POWERHOUSE ULTIMO REVITALISATION

Public Domain
& Landscape
Statement

RTS

3.1 Soil

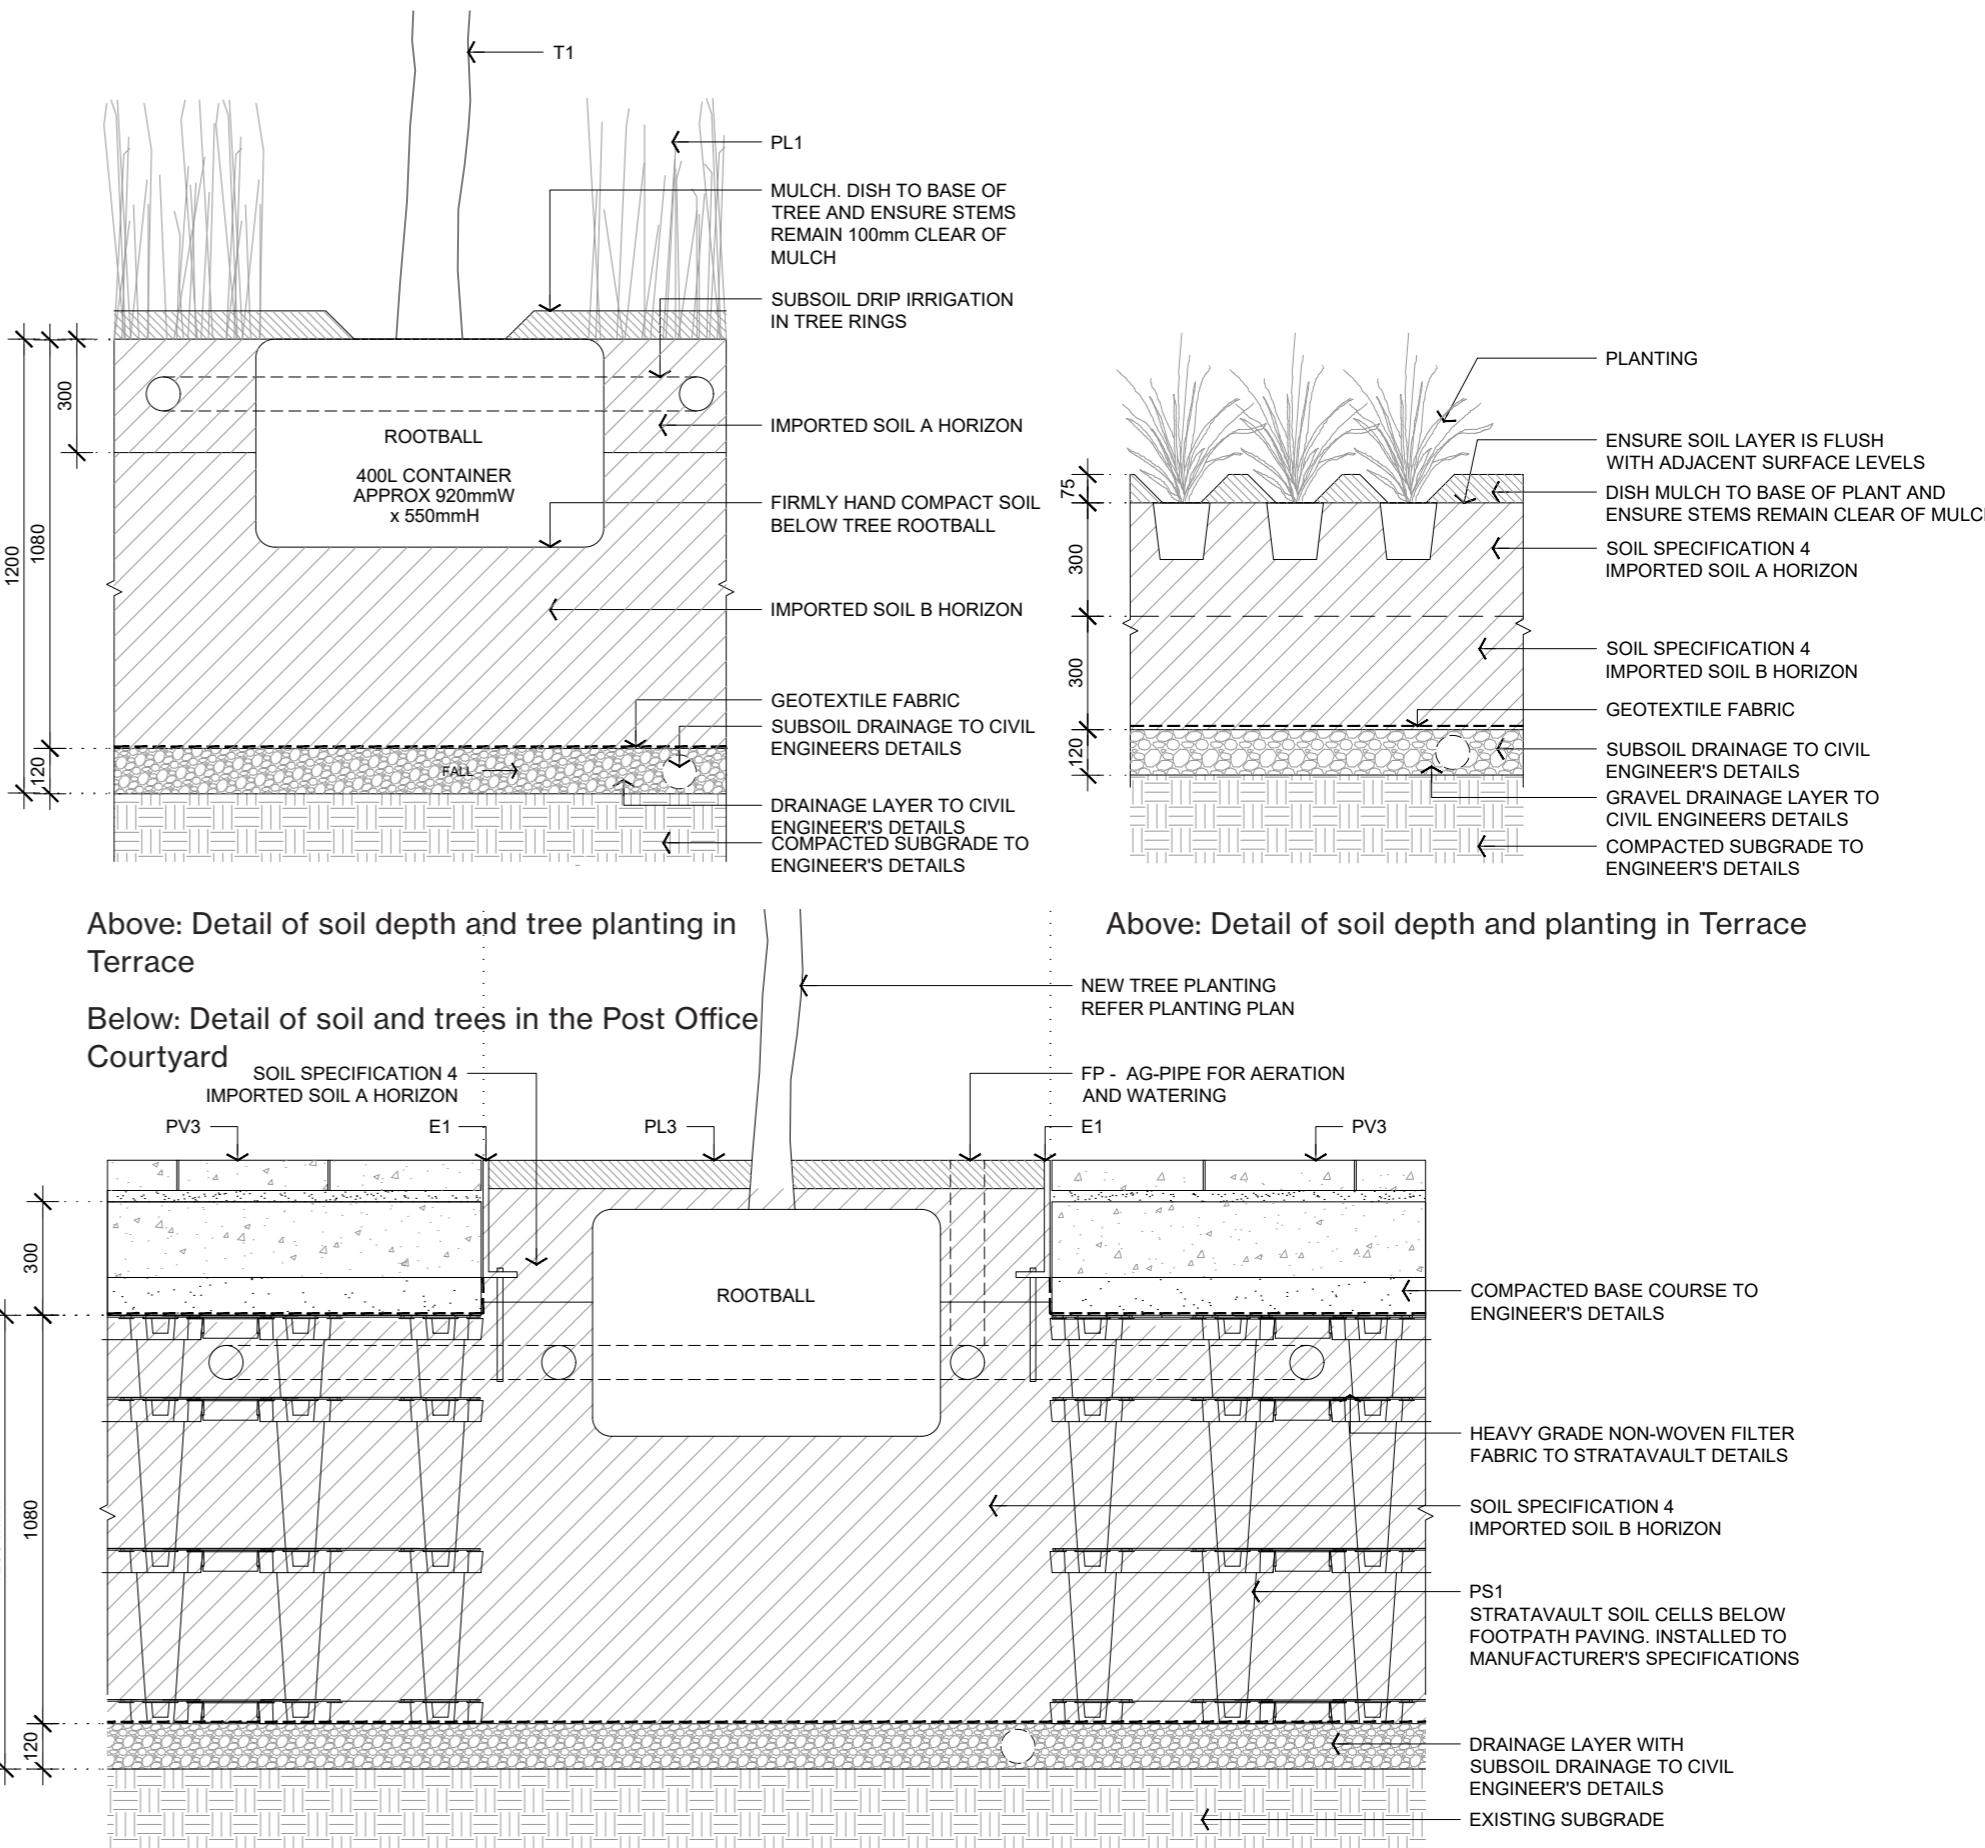
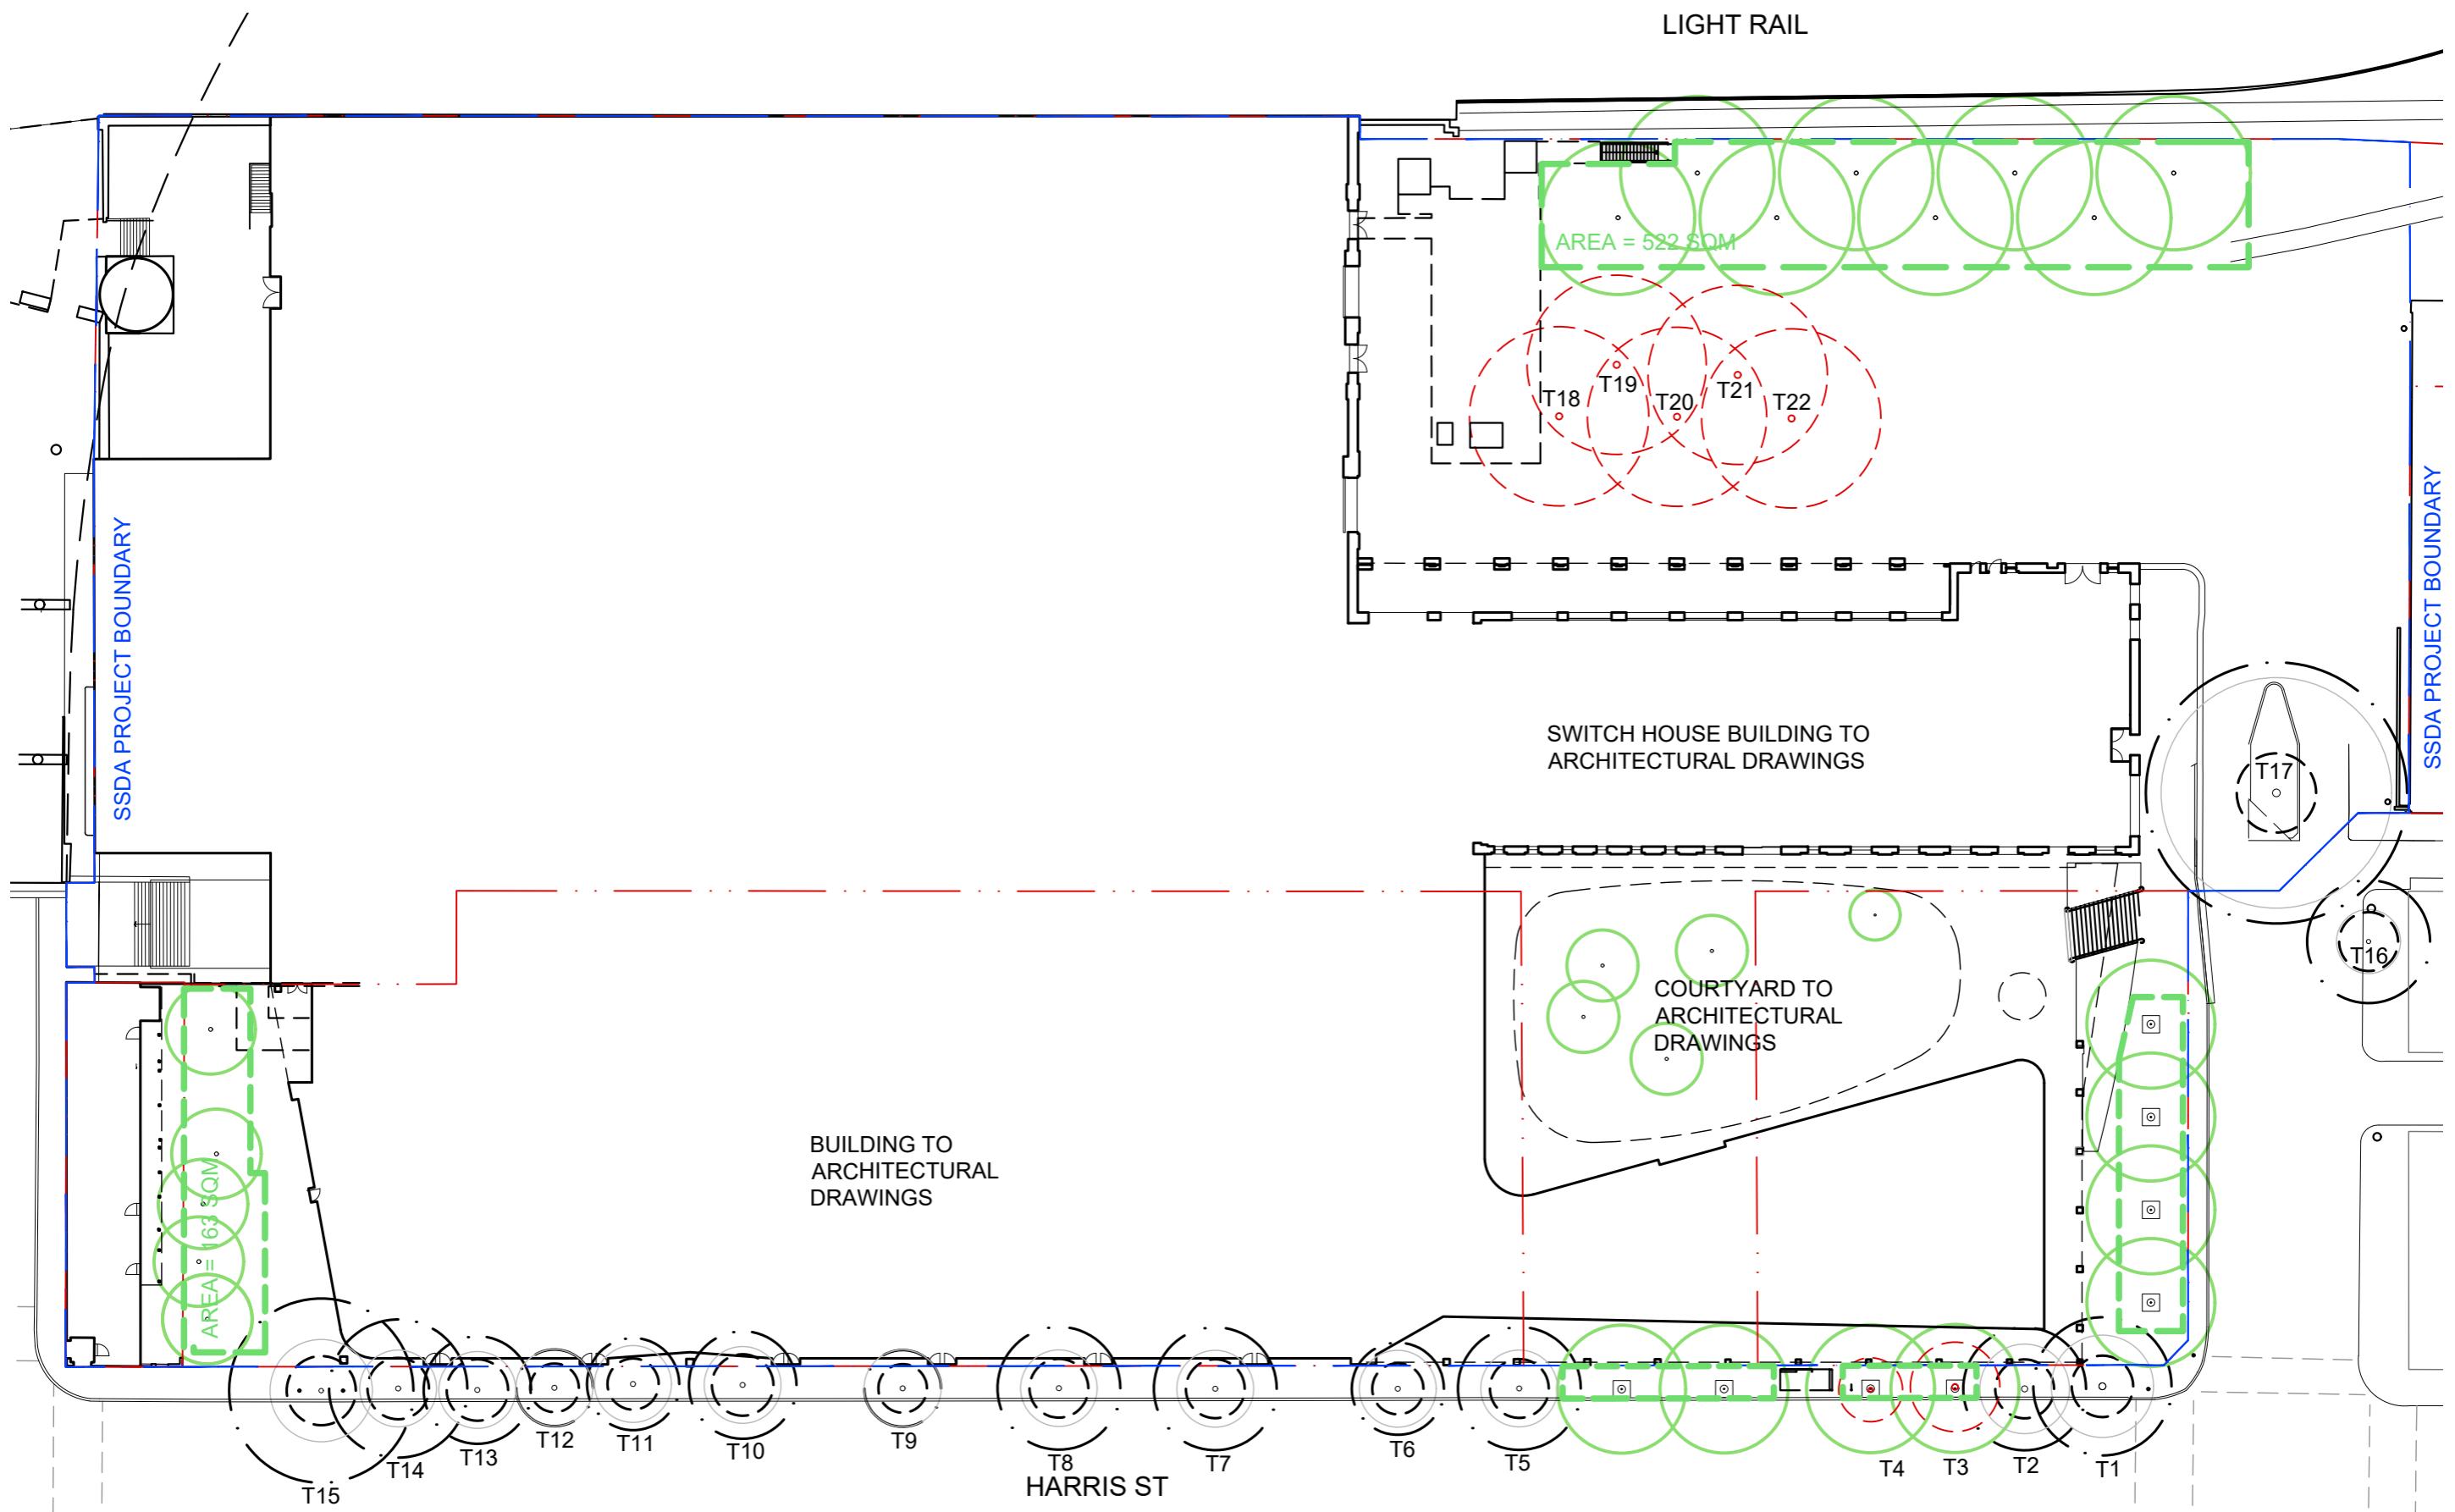
- Across the project, care has been taken to include ample quantities of the correct soil to enable optimum tree and plant growth.
- The deep soil plan has been updated and the extent is illustrated on the plan on the following page.
- For the Terrace landscape, the entire planted area is deep soil. The dimensions of the soil trench surrounding the proposed trees have been provided on the plans on the following pages. The soil trench is 522m³. Where paths cross this trench, they are founded on structural soil to allow extensive lateral root growth.
- For the Post Office Courtyard landscape, soil cells soil support the surrounding hardscape to ensure tree roots have ample space to extend in a horizontal direction.
- All of these trees have access to a 163m³ volume of connected soil. Where this soil is beneath the trafficable slab, it will be aerated and irrigated. See detail this page.

3.3 Trees in streets and footpaths

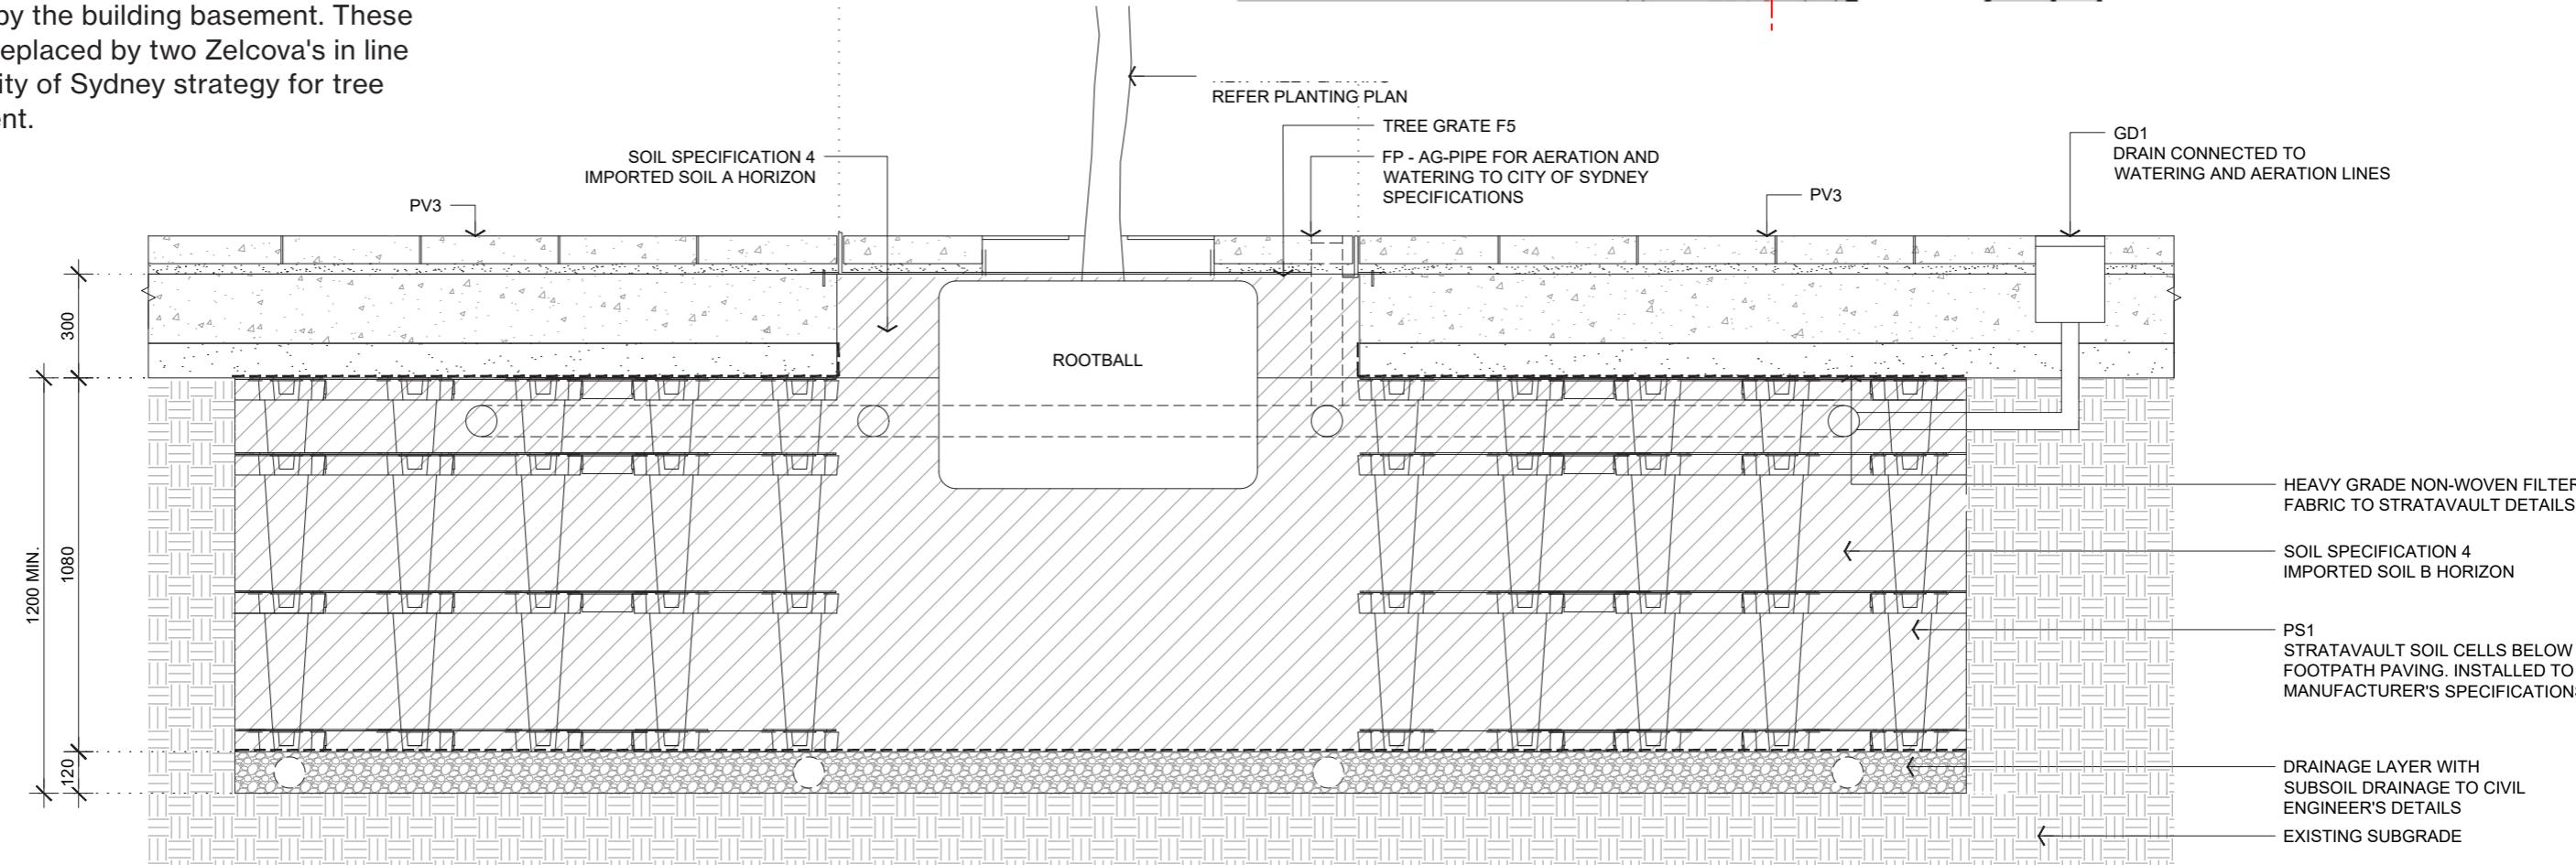
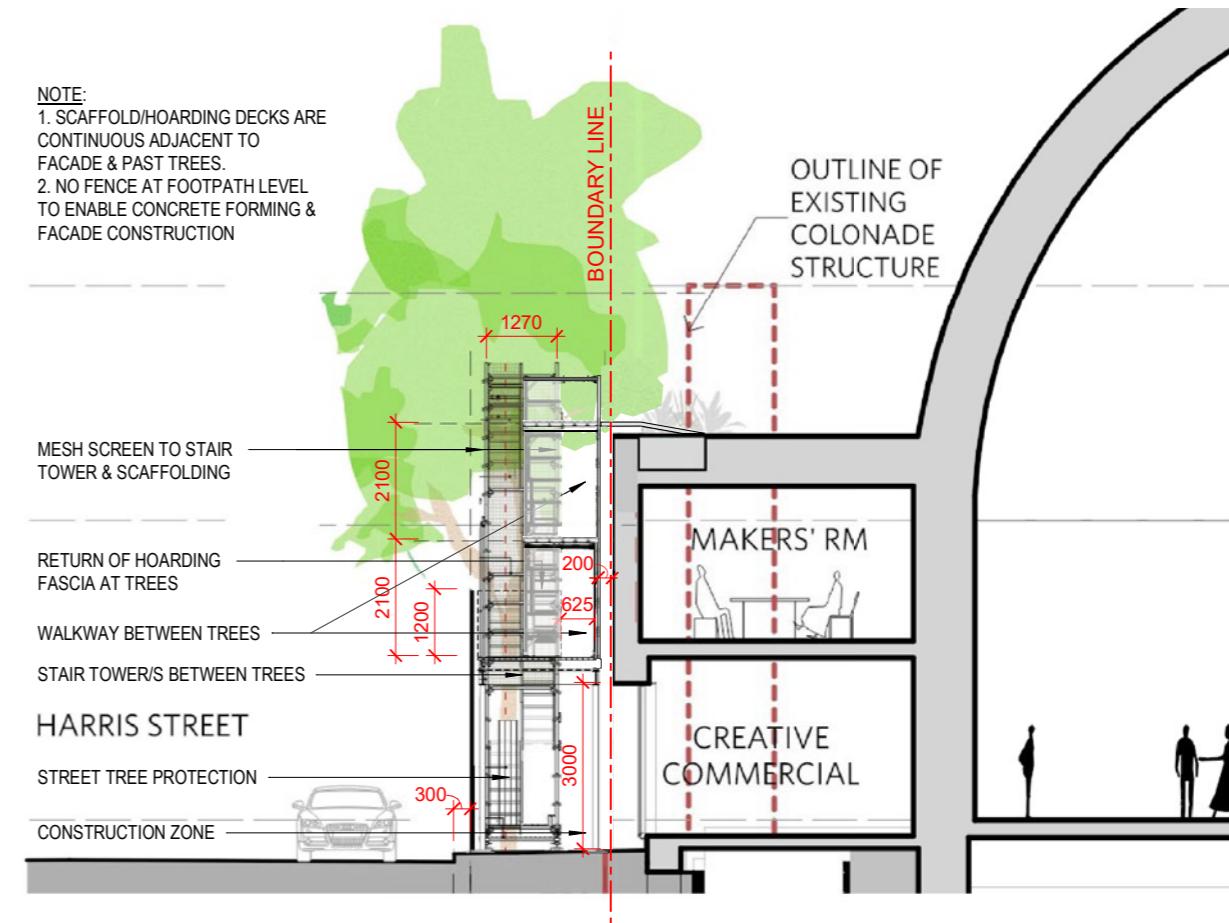
- Harris Street and Macarthur Street footpaths are paved with new custom precast concrete paving. This is to ensure a high quality finish and also to create the sense of a cohesive precinct occupied by the various buildings of the Powerhouse Museum.
- New trees are within tree grilles as per the detail on this page.
- Provision for scaffolding has been tested on Harris Street allowing the retention of the Plane Trees.
- 2 Plane trees are removed as they are impacted by the building basement. These trees are replaced by two Zelcova's in line with the City of Sydney strategy for tree replacement.
